MIL-R-81553A(AS)
AMENDMENT 2
16 July 1990
SUPERSEDING
AMENDMENT 1
12 August 1987

REGULATOR, CHEST MOUNTED, 100 PERCENT OXYGEN, POSITIVE PRESSURE, CRU-79/P

Figure 4. Location of regulator outlet of piezometer (62-A-116-C48).

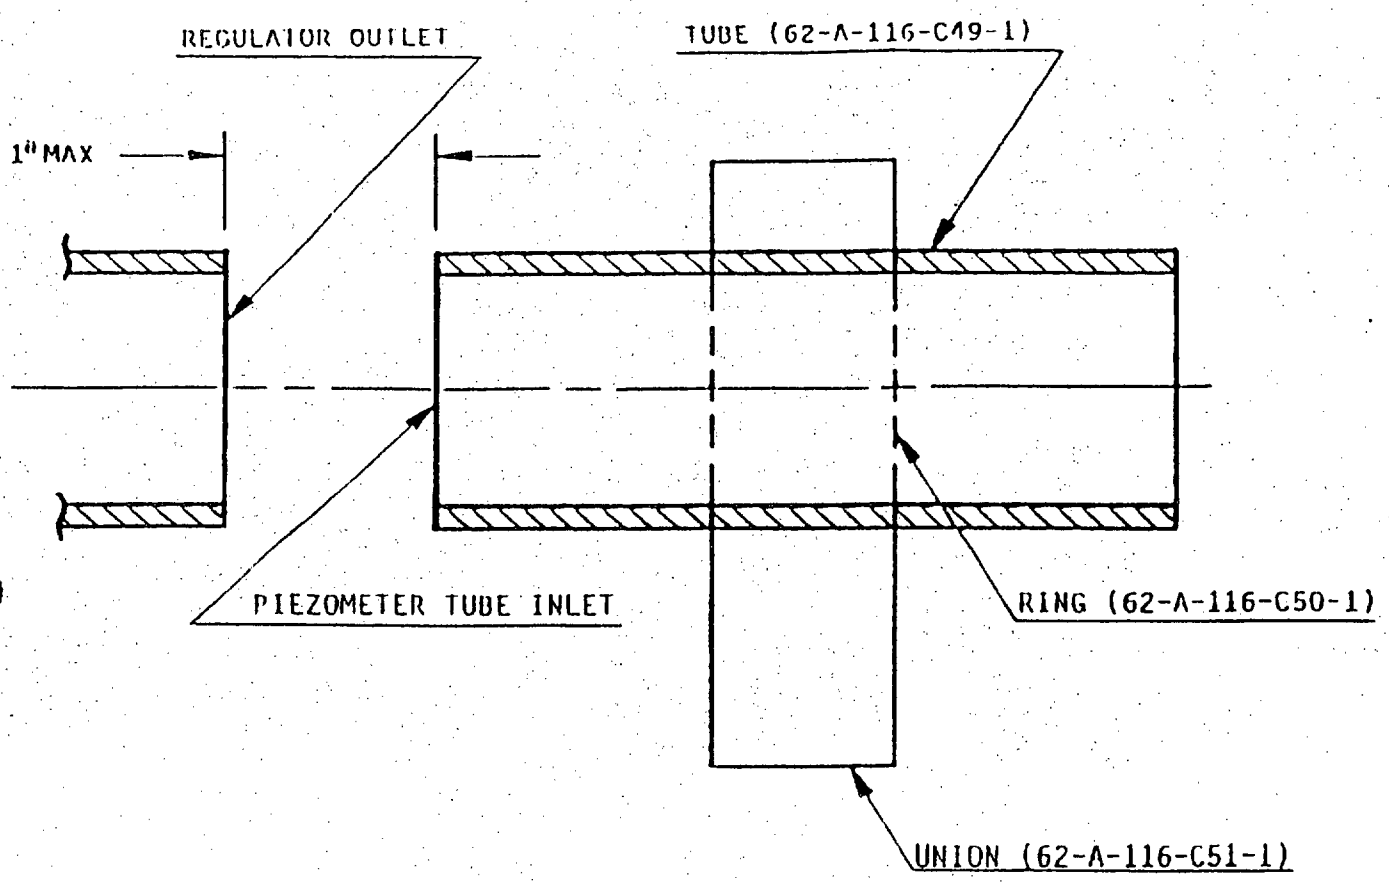
4.7.5, third sentence: Delete and substitute "The piezometer shall be connected to the mask end of the regulator as shown in Figure 4.

Add Figure 4:
